WASTE TREATMENT AND IMMOBILIZATION PLANT (WTP) LOW ACTIVITY WASTE (LAW) STRUCTURAL REPORT

CONTRACT NO. DE-AC27-01RV14136 – LOW-ACTIVITY WASTE (LAW) PEER REVIEW
STRUCTURAL REPORT

ORP Structural Peer Review Report

LAW Vitrification Building

Figure 5-1 Comparison of UBC-97 and IBC-2000 Spectra

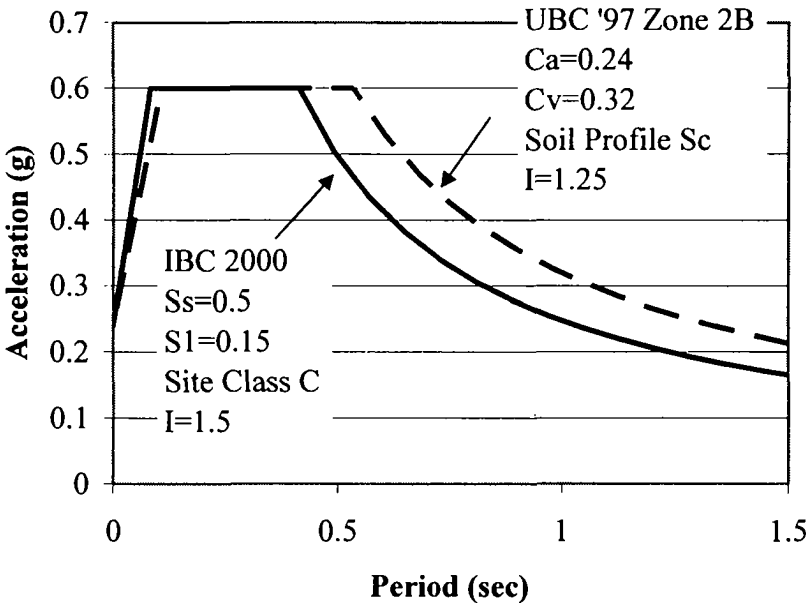
DOE-STD-1020-2002 references IBC-2000, with an importance factor, I, of 1.5 for PC-2 buildings. The IBC-2000 input spectra, with I=1.5, is compared to the UBC-97 seismic spectra used in the LAW design in Figure 5-1. These two spectra are essentially equal in the LAW fundamental period (about 0.4 sec). Thus, the seismic input used to design the LAW is consistent with DOE-STD-1020-2002.

Figure 7.3 UBC '97 Base Shear Spectra

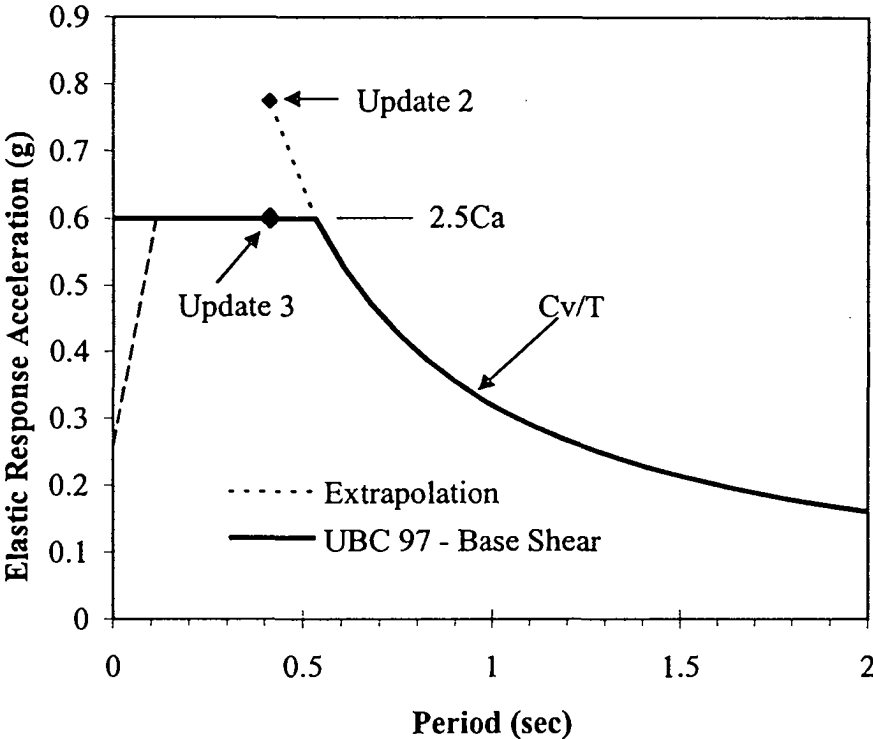
The free field spectra used to calculate the UBC '97 base shear is shown in Figure 7.3. In the long period, or constant velocity, portion of the spectra, acceleration is C_v/T , where C_v is 0.32g-sec and T is the natural period of the structure. In the short period, or constant acceleration, portion of the spectra, the acceleration is $2.5C_a$, where $C_a=0.24g$. From the original analysis, up to and including Update 2, the LAW seismic loading was determined by extrapolating the equation for the constant velocity portion of the spectra into the constant acceleration region. Beginning in Update 3 the correct portion of the spectra was used to determine seismic loads.

Figure 7.4 Cumulative Story Shears

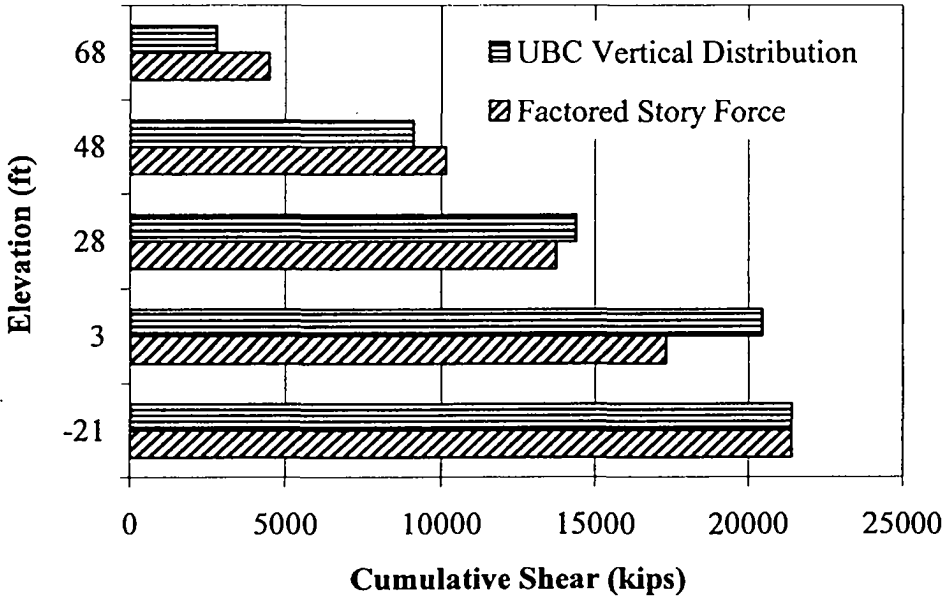
Cumulative shear is derived from Table 7.3 by summing the UBC Vertical Distribution and the Factored Story Force and is shown in Figure 7.4. Note that at elevations 28 ft and 3 ft the cumulative shear due to the factored modal story force is less than the UBC vertical distribution. The PRT recommends that BNI justify the use of the cumulative shear distribution d in their design.
